SUBJECT: COMANCHE PEAK NUCLEAR POWER PLANT, UNITS 3 AND 4
DOCKET NUMBERS 52-034 AND 52-035
RESPONSE TO REQUEST FOR ADDITIONAL INFORMATION NO. 5092
(SECTION 3.8.4)

RAI NO.: 5092 (CP RAI #185)

SRP SECTION: 03.08.04 - Other Seismic Category I Structures

QUESTION NO.: 03.08.04-86

Figure 1

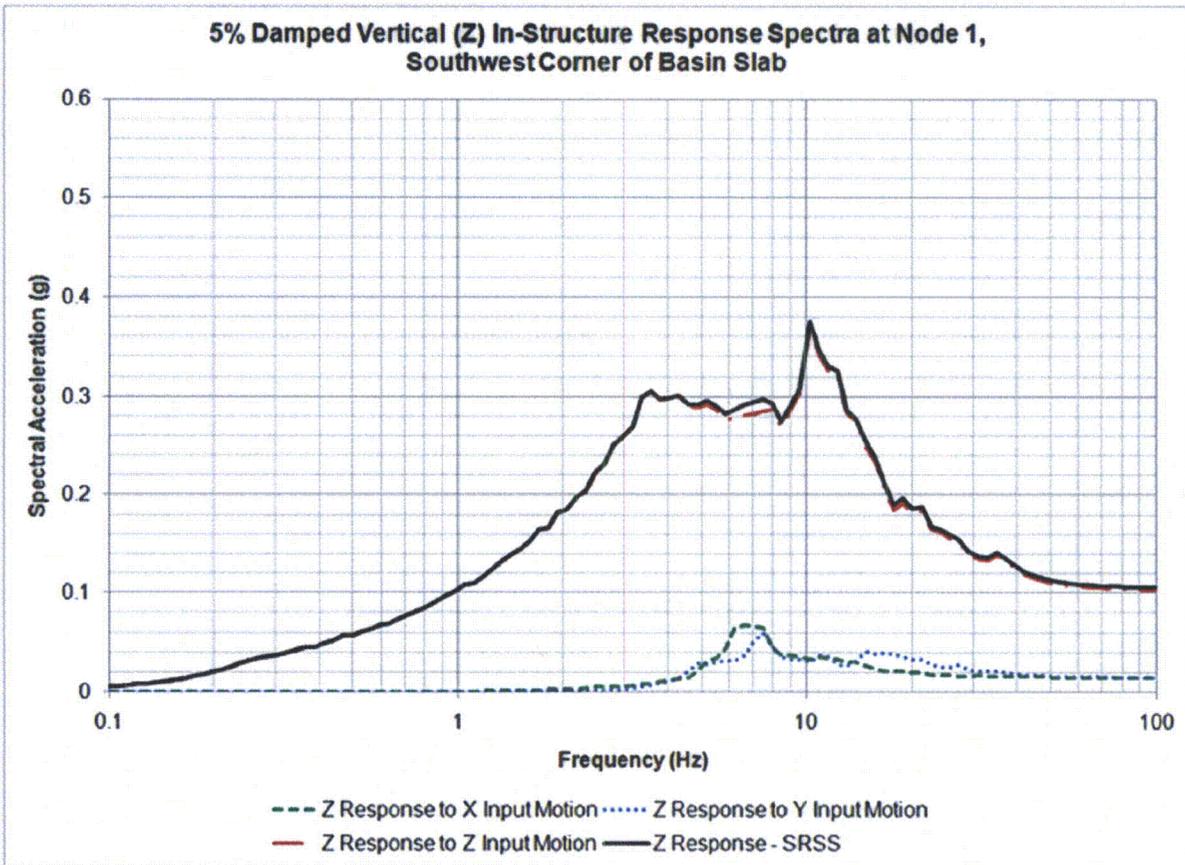
The Applicant is requested to provide information that explains how the fluid masses corresponding to the base rocking motion are calculated and included in the model, taking into account the staff's comments cited above.

The SSI analyses use a full three-dimensional structural model supported by the free field soil without nodal constraints and is therefore capable of modeling rocking motion. The extent of SSI-induced rocking for the UHSRS is examined through a comparison of the vertical best-estimate soil 5% damped in-structure response spectra components at node 1, located at the southwest corner of the basin slab, and node 2166, located at the northwest corner of the basin slab. These comparisons are shown in Figure 1 and Figure 2, respectively. Since these locations are at edge corners stiffened by the outer walls, any rocking of the structure due to horizontal input motion is observed as vertical motion of the corner node.

As shown in the figures below, there is very little rocking present in the structure, on the order of 0.02 g peak ground acceleration and nearly zero in the low frequency regions that would excite convective modes. The lack of significant rocking is consistent with the stiff subgrade of this foundation supported on limestone.

Since the UHSRS is not experiencing significant motions representative of base rocking, additional consideration of modeling to capture the effect of base rocking on hydrodynamic pressures is unnecessary.
